## INTEROFFICE MEMORANDUM

**SUBJECT:** Overhang Brackets

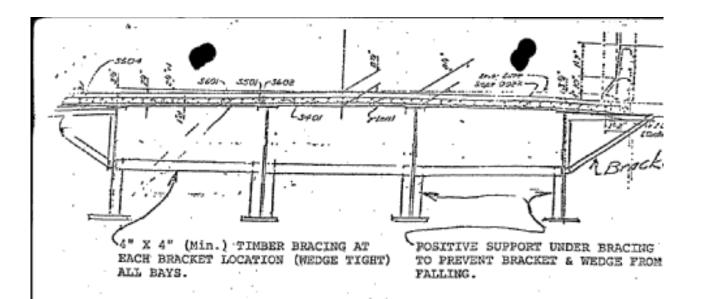
Please add the following note to all overhang bracket drawings approved for future projects:

Overhang forming checked for stresses only, deflection of overhang due to loadings must be determined and adjustments made therefore in the field.

If a transverse finishing machine is used the rail shall be supported directly over the exterior beams or as an alternate the rail may be supported by the overhang brackets if the above strutting system is used. SCREED RAIL SUPPORT.
